AGENDA – WORKSHOP OF THE PLANNING & ZONING COMMISSION OF THE CITY OF PEARLAND, TEXAS, TO BE HELD ON MONDAY, NOVEMBER 15, 2010, AT 6:00 P.M., IN THE COUNCIL CHAMBERS, CITY HALL, 3519 LIBERTY DRIVE, PEARLAND, TEXAS.

**AGENDA REQUEST
BUSINESS OF THE CITY COUNCIL
CITY OF PEARLAND, TEXAS**

AGENDA OF: November 15, 2010	ITEM NO.: Workshop No. 2
DATE SUBMITTED: November 5, 2010	DEPT. OF ORIGIN: Planning
PREPARED BY: Harold Ellis	PRESENTOR: Harold Ellis
REVIEWED BY: Mike Hodge	REVIEW DATE: November 9, 2010
SUBJECT: Request of Terra Associates, applicant, for a Joint Workshop regarding a proposed amendment to the previously approved Pearland Commons Planned Development	
EXHIBITS: Application for workshop, proposed site plan, proposed elevation, proposed Planned Development Draft Ordinance, previously approved Pearland Commons Site Plan, Phasing Plan, Elevation examples, and Project identifier	
EXPENDITURE REQUIRED: N/A AMOUNT AVAILABLE: N/A ACCOUNT NO.: N/A	AMOUNT BUDGETED: N/A PROJECT NO.: N/A
ADDITIONAL APPROPRIATION REQUIRED: N/A ACCOUNT NO.: N/A PROJECT NO.: N/A	
To be completed by Department: <input type="checkbox"/> Finance <input type="checkbox"/> Legal <input type="checkbox"/> Ordi

Previously Approved Pearland Commons Conceptual Site Plan Being Replaced with the Current PD Proposal:

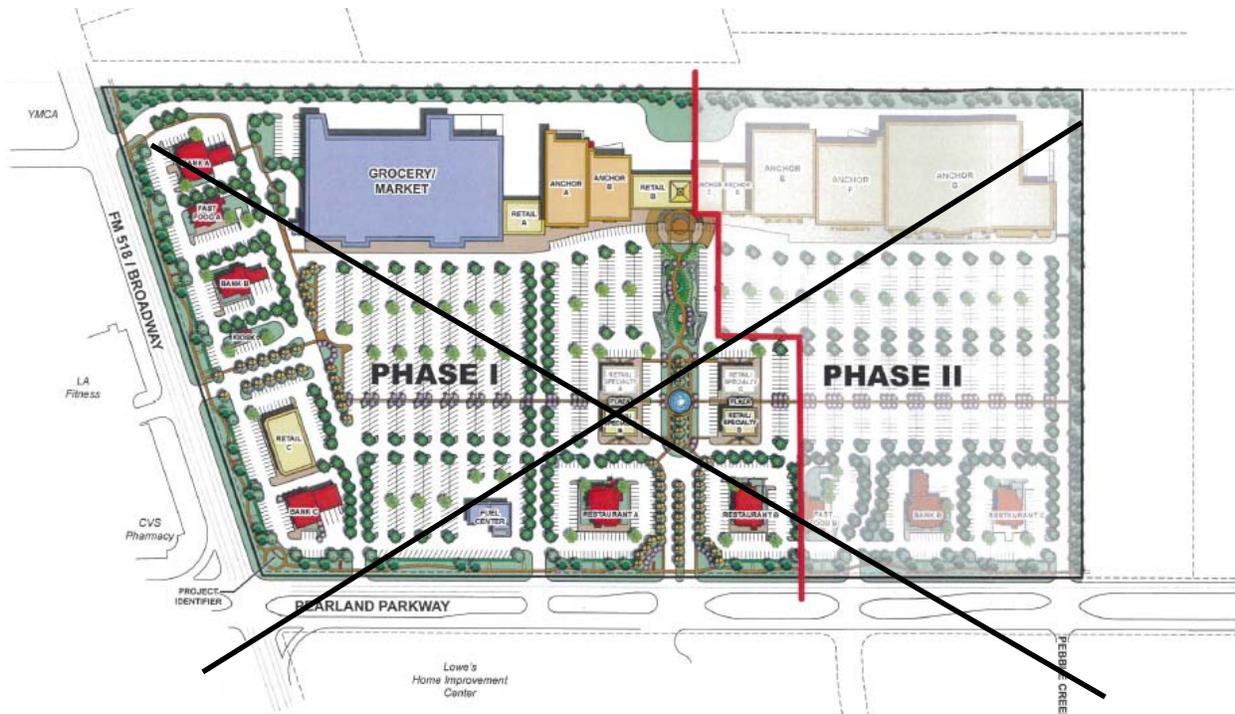
A reduction in area for the overall PD district significantly reduces the ability to comprehensively plan for the entire developed, which was an opportunity given to the City by the previously approved PD.

The current proposal also eliminates the majority of the enhanced amenities which gave the previously approved PD the superior quality development as required for a PD district.

All of the main amenities being proposed with the new PD development have been removed from the site.
